STAFF REPORT: 09-08-2021 MEETING

APPLICATION NUMBER: 21-7400

ADDRESS: 630 VIRGINIA PARK

SCOPE OF WORK: REPLACEMENT OF HISTORIC WINDOWS* (WORK COMPLETED WITHOUT APPROVAL)

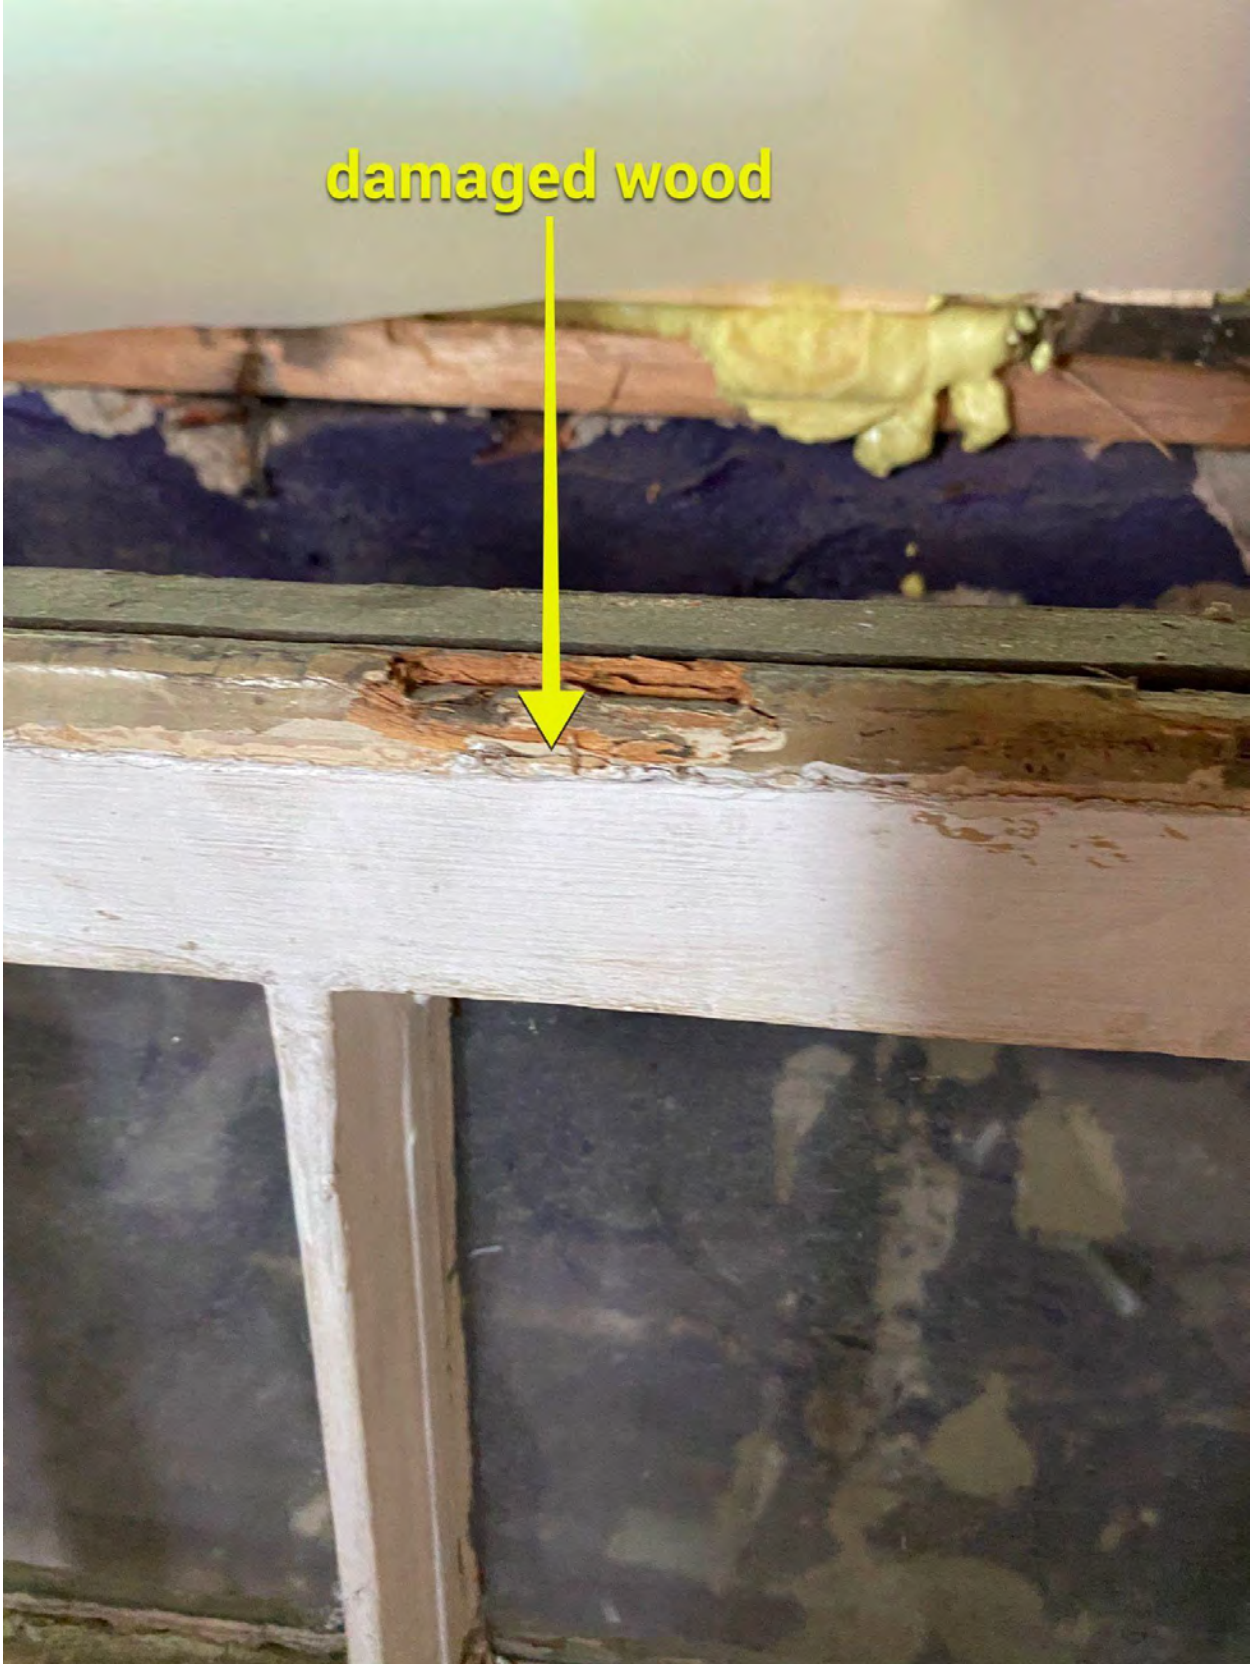
- The notated photographs within the current submittal give evidence of deterioration that can be typical of window sash that are more than 100 years old. The photographs submitted do not show such advanced deterioration to render the windows not repairable, nor requiring a disproportionately high level of repair.

all glazing needs replacement

Rot and mold

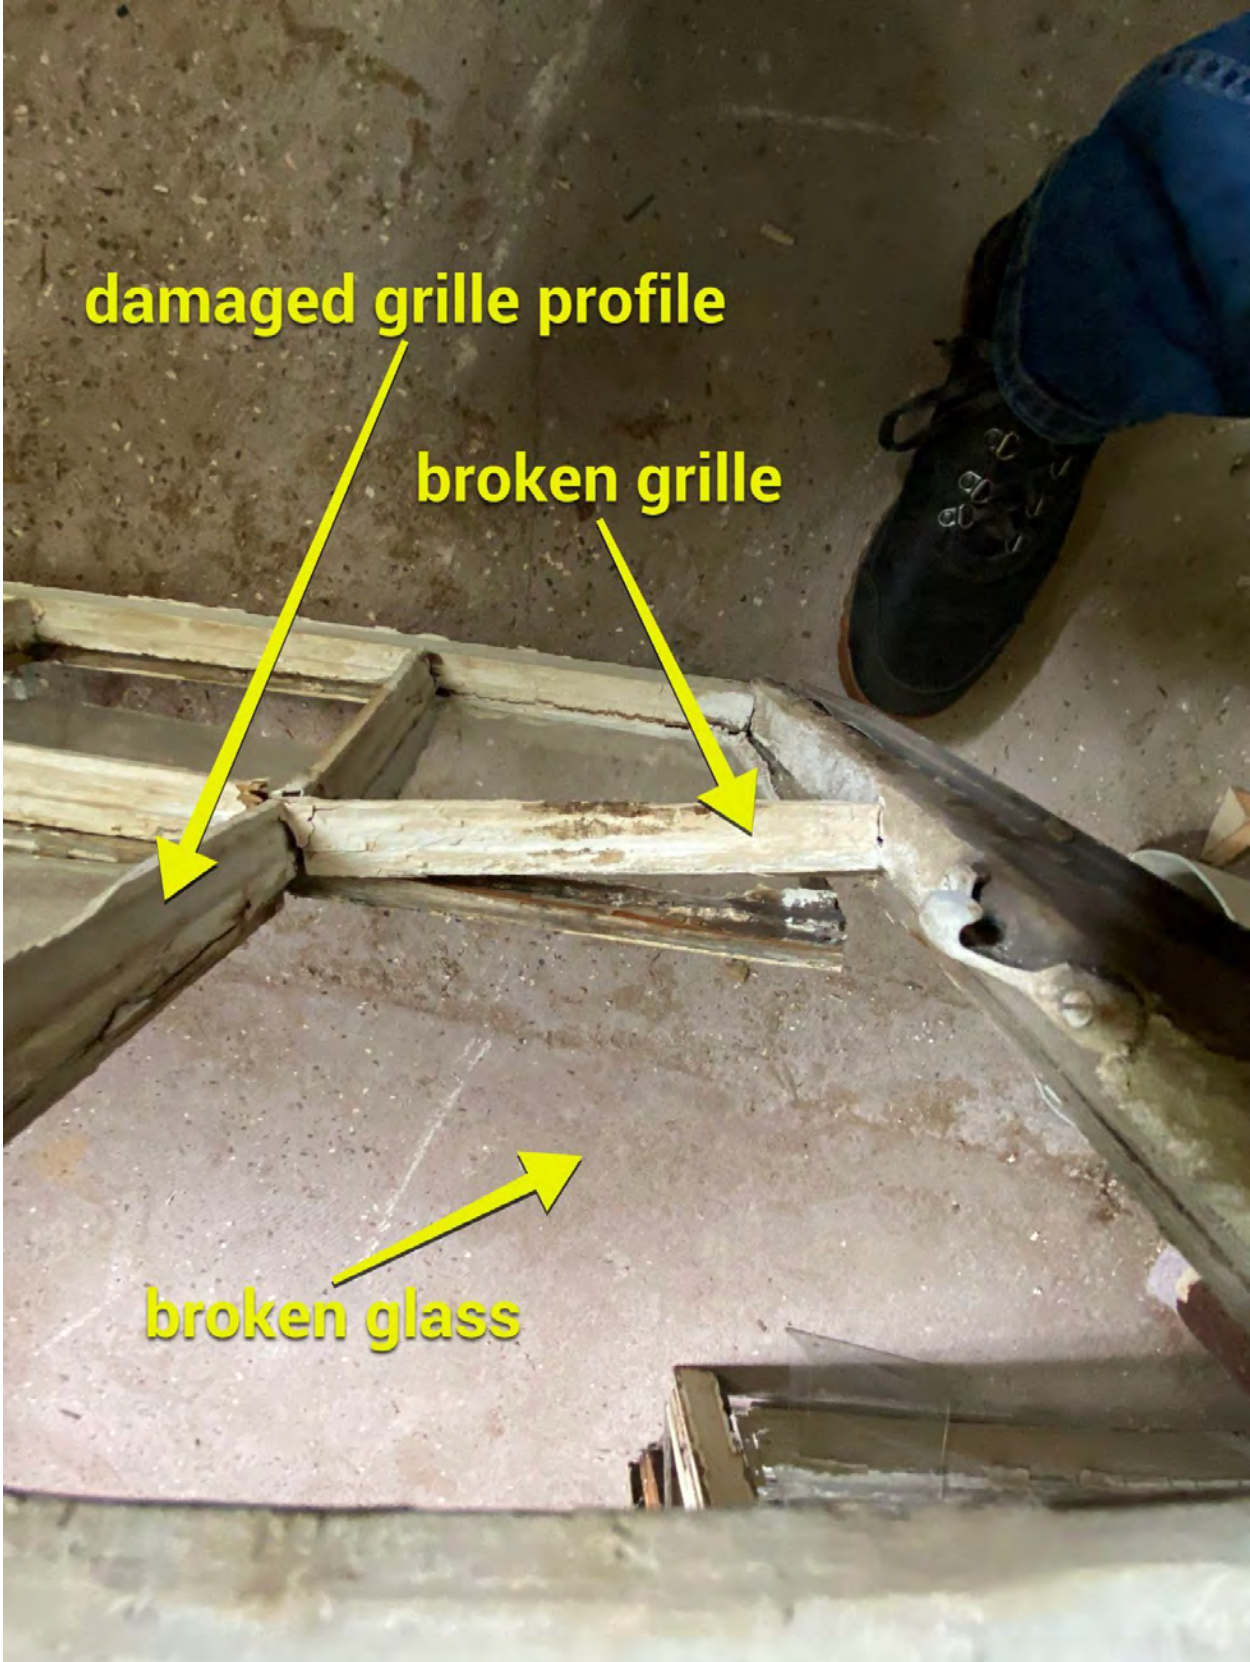
damaged grille profile

broken grille

broken glass

Examples of typical damage

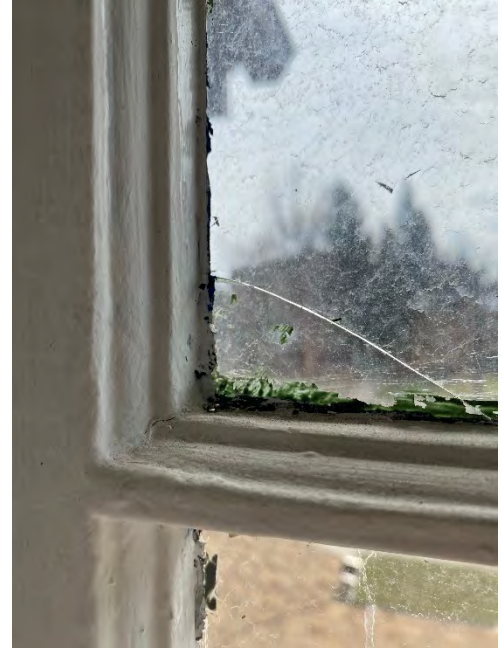
Broken Glass

Operating hardware missing or inoperable

Rot at window sashes
